Arlington Historic District Commissions

Application for Certificate

Property Address 51 Academy Street District _____
 Owner(s) Rene Le Email ReneLe@aol.com
 Owner's Phone (h) 617-642-4580 (w) _____ (fax) _____
 Owner's Address 10 Bow Street, Sausalito, CA 94965
 Applicant (if not Owner) _____
 Applicant's Phone (h) _____ (w) _____ (fax) _____
 Applicant's Address _____
 Applicant's Relationship to Owner _____
 Contractor RLE General Contracting Phone 617-642-4580
 Architect _____ Phone _____

- Remove two windows and create a new one in the space between them.
- Replace bulkhead plywood doors with steel cellar doors.
- Replace backsteps with wooden steps and demo concrete wall.

Exhibit I: Backsteps

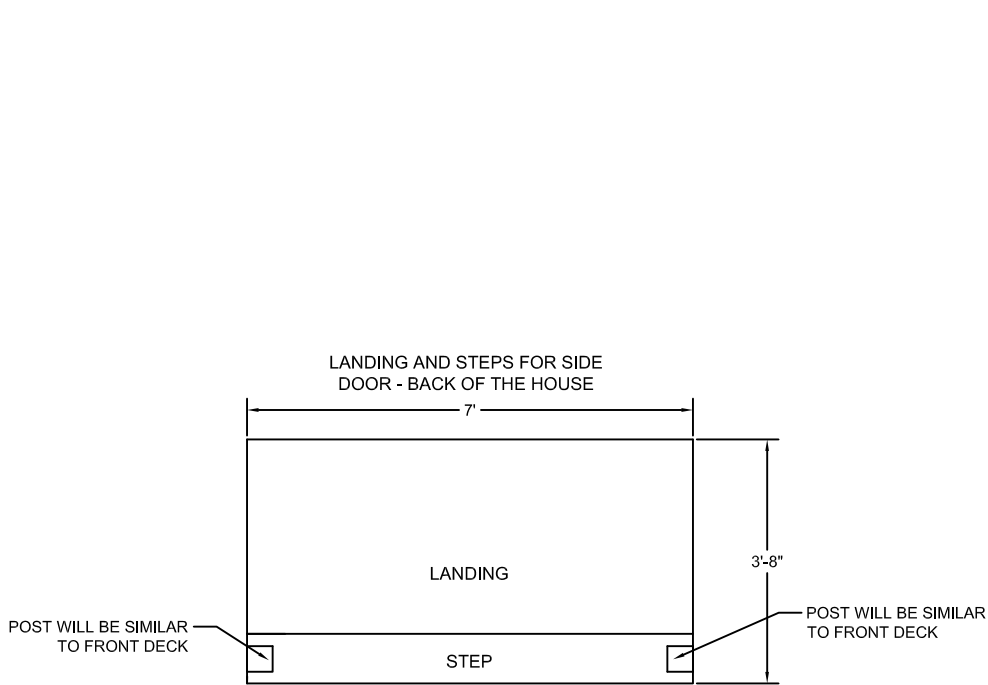
- 1) Can you confirm that one of the two existing windows will be restored and moved over to the proposed new location? What will happen to the other window (i.e., will it be reused elsewhere?)
- 2) Do you have any specifications for the proposed bulkhead? I assume it will be approximately the same size/design as the existing one except in steel.
- 3) You propose wooden stairs but provide no design or materials specifications. Can you provide at least rough drawing and specifications of the materials to be used (i.e., will there be a landing?, handrails?, balusters, etc.?)

- The existing stairs have two different configurations. Please include a drawing that shows the one with roof and the other.
- Include photos of the existing porch rail, balustrade, and columns that you intend to duplicate at the back steps.
- Include drawings that detail the finishes: treads, risers, skirts, and sides of the landing.

- 3) You propose wooden stairs but provide no design or materials specifications. Can you provide at least rough drawing and specifications of the materials to be used (i.e., will there be a landing?, handrails?, balusters, etc.? **We plan to use the same materials as the deck in front of the house. I can put together a rough drawing to specify the landing, handrails and balusters. I will try to get the drawings over to you by this week.**
